Point by Point Response to CC2

In general, all the authors of this manuscript shall show their appreciations to the community comments from Dr. Gerald Turner (CC2) on amt-2023-242, some (i.e. Comment 01 and Comment 09) of which do help us to improve our paper. Here, point-by-point responses to these comments are provided as follows:

General Comment: The manuscript deals with the problem of nonlinear correction in hyperspectral infrared sounders of GIIRS. The authors attempt to provide a new nonlinear correction method based on the NL parameter estimation from the pre-launch radiometric calibration tests. However, the authors seem do not understand the cause of nonlinearity in infrared sounders, so the correction methods provided are not clear in logic. The final calibration results after nonlinear correction are not in accord with the calibration characteristics of similar instruments. In addition, the English writing and illustrations are terrible. I recommend that this manuscript be rejected for publication. I also recommend that the editor find other experts who are familiar with infrared sounder radiometric calibration to review this manuscript again. (e.g. Robert Knuteson, D

(a) ΔBT after NL correction for 56th detector

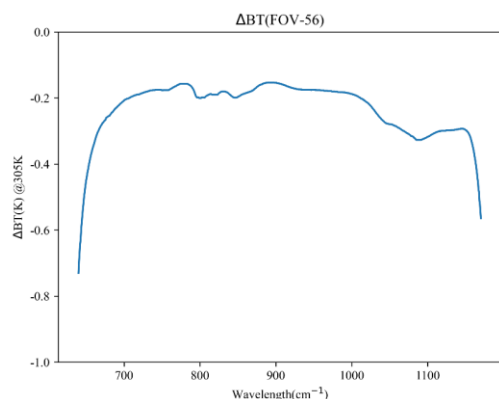
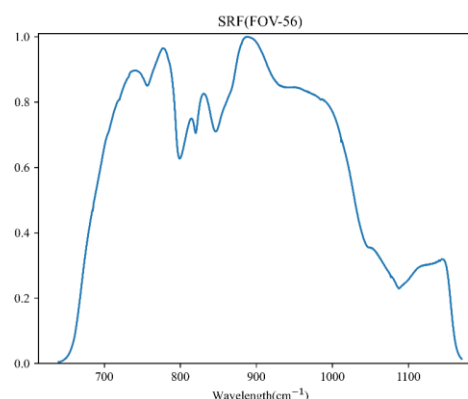
Comment 35: From Figure 11 it can be confidently confirmed that the radiometric calibration failed, let alone the non-linear correction. According to pre-launch radiometric calibration tests such as IASI and CrIS, the BT deviation of the blackbody calibrated spectra should not have significant spectral characteristics, and its mean value should be a straight line trend along the spectral abscissa. In Figure 11, The BT deviation still remains the characteristics of the instrument's spectral responsivity. It means that the calibration does not eliminate the instrument effects, thereby defeating the purpose of radiometric calibration.

Response 35: The comment is irresponsible from a technical perspective or maybe Dr. Gerald Turner (CC2) does know little about radiometric calibration of an infrared sensor. As shown in equation 1, the outcomes (DN) of a sensor will be calibrated according to the incident radiance which should be known ahead of time. Here, the physical quantity to be calibrated is radiance rather than BT. Thus, in this sentence of “its mean value should be a straight line trend along the spectral abscissa” given by CC2, the mean value should be referred to radiance instead of BT, while both ΔBT and delta radiance are not proportional within infrared spectral range. Meanwhile, the influence of NL upon smaller incident

radiance (i.e. measurements at the marginal position of SRF for a FTS) is much more than those of bigger ones (i.e. those near the central position of the whole spectral band). Here, the ΔBT after NL correction and its SRF of 56th detector of FY-4B/GIIRS are shown for comparison as in the following figures (a) and (b), respectively. Clearly, the characteristics of detector's SRF is almost eliminated particularly for main spectral region (i.e. 700-1000 cm^{-1}). Therefore, the results of figure 11 are relative reasonable doubtlessly.
